UNITED STATES PATENT AND TRADEMARK OFFICE

APPLICATION NO.	FILING DATE	FIRST NAMED INVENTOR	ATTORNEY DOCKET NO.	CONFIRMATION NO.
10/748,650	12/30/2003	Lee Delson Wilhelm	19,927	6898
23556 7590 08/14/2007 KIMBERLY-CLARK WORLDWIDE, INC. Catherine E. Wolf 401 NORTH LAKE STREET NEENAH, WI 54956			EXAMINER AFZALI, SARANG	
			ART UNIT 3726	PAPER NUMBER
			MAIL DATE 08/14/2007	DELIVERY MODE PAPER

Office Action Summary

DETAILED ACTION

FIGURE 7E

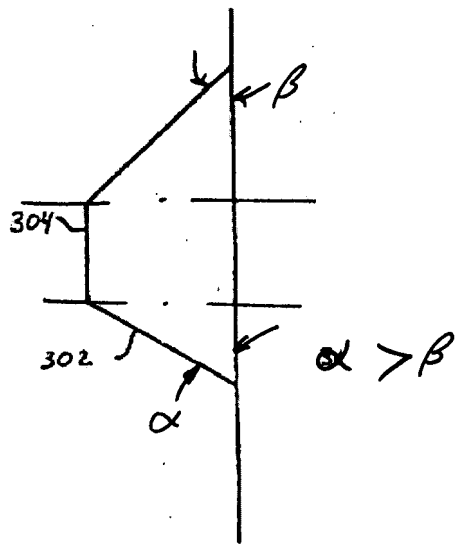
As applied to claims 1-5, Makoui et al. teach an apparatus comprising: a surface containing at least one embossing element (embossing element 22 of the embossing

roller 26, Fig. 1) having a top comprising a flat surface (flat top 304, Fig. 7E); the embossing element having a first sidewall (302, Fig. 7E) extending from a base to the top having a first sidewall angle and a second sidewall (302', Fig. 7E) opposing the first sidewall (see markup of Fig. 7E), the second sidewall extending from the base to the top and having a second sidewall angle; and wherein the first sidewall angle is different than the second sidewall angle.

In Fig. 1, Makoui et al. teach there are multiple embossing elements (24) with a pair of exterior and pair of interior first and second sidewalls separated by a gap extending from the top towards the base. Makoui et al. teach that first sidewall angle (α) is greater than the second sidewall angle (β) by about 5 degrees or more (and 15

degrees or more) and also teach that embossing element comprises a male embossing element resulting in upstanding land areas 30 on a web material (Figs. 1 & 7E).
